SUNDRY NOTICES AND REPORTS ON WELLS
Do not use this form for proposals to drill or to re-enter an abandoned well. Use form 3160-3 (APD) for such proposals.

BP America would like to request permission to temporary abandon the subject well. Our future plan for the well is to perform a recompleat job. *TA approved until 10/1/13*

GCU 157E
Dakota
API #30-045-26398
Sec 35 T28N, R13W
San Juan County, NM

T&A wellbore:

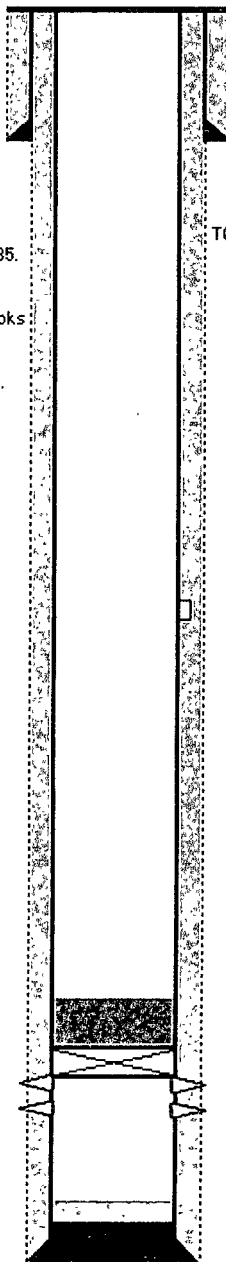
** Run Cement plug on top of CIBP/CR down to at least 6140' see #11 on next page*

100' of cement
6190'-6090'
CIBP @ 6190'
